2016SYE051 – 103-113 Willarong Road Caringbah

DA16/0388

ASSESSMENT REPORT APPENDICES

Architectural Review Advisory Panel

Image 1: Master Plan – portion of Building N and O subject to this Clause 4.6 Exception to the height standard (Source: Tier Architects)

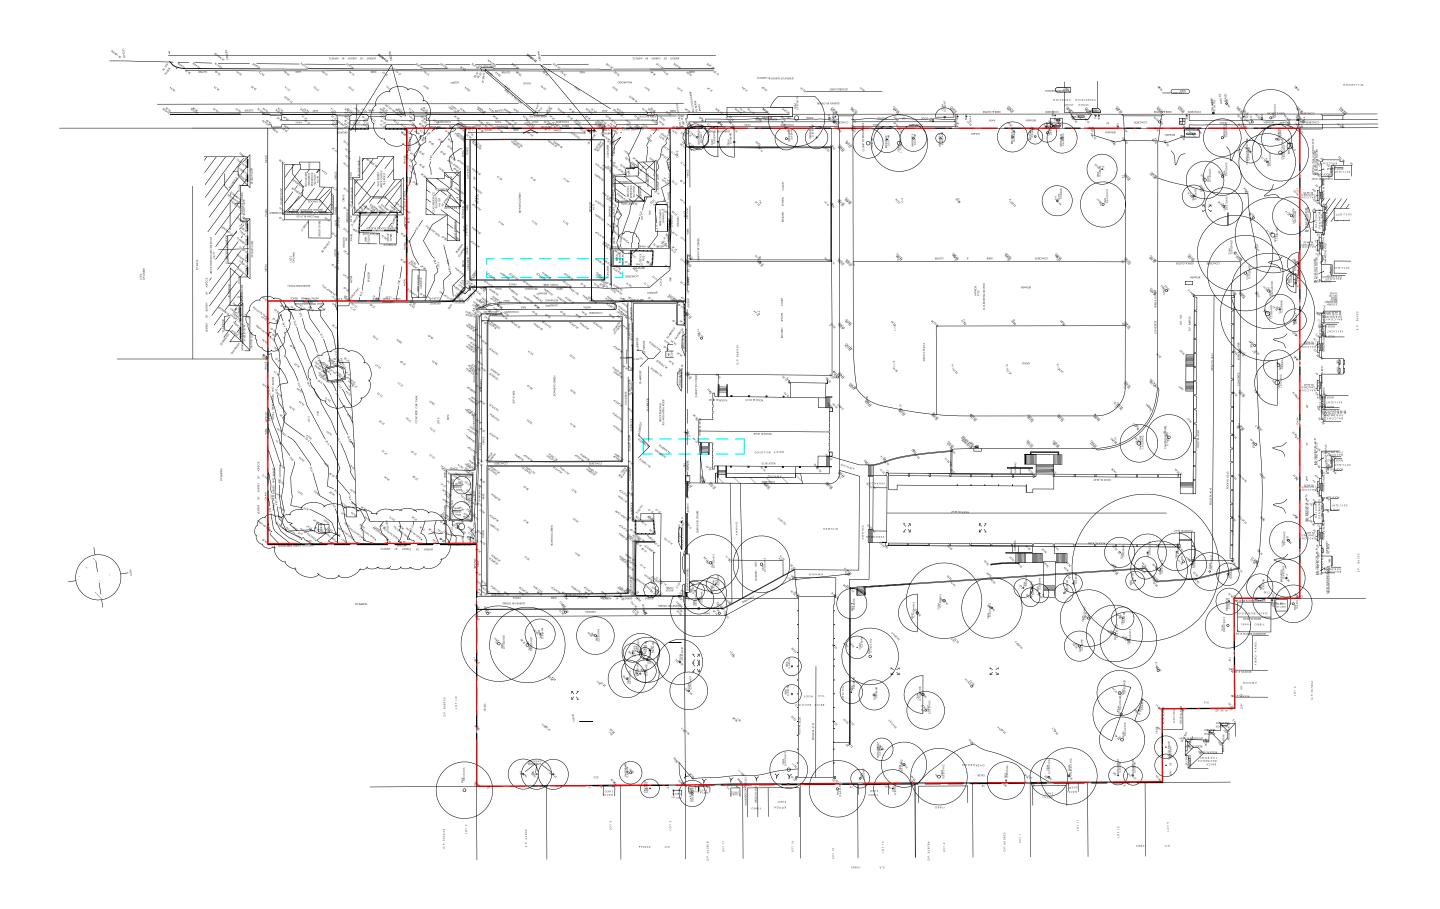
This is shown in red in the following extract of the architectural plans:

As such, the height variation is limited to certain portions of Buildings N and O and the portion of these buildings is dictated by their positioning within the master plan. The Concept Master Plan undertakes an integrated approach to redeveloping the combined site by providing a new road network, landscaping, community facilities and new residential apartments. The resultant location of Buildings N and O is due to the rectilinear grid network of the master plan, the location of the new road network, and open space areas to service the precinct.

To this effect, the height variation is a consequence of the design of the Concept Master Plan, where Buildings N and O straddle the boundary of the two lots and therefore results in a portion of the buildings departing from the standard.

Figure 1 demonstrates the portion of building's N and O that does not comply with the height standard. The portions are not substantial and if they were to be deleted they would not have any lesser visual impact from an adjoining property, street or public reserve, than if they were retained.
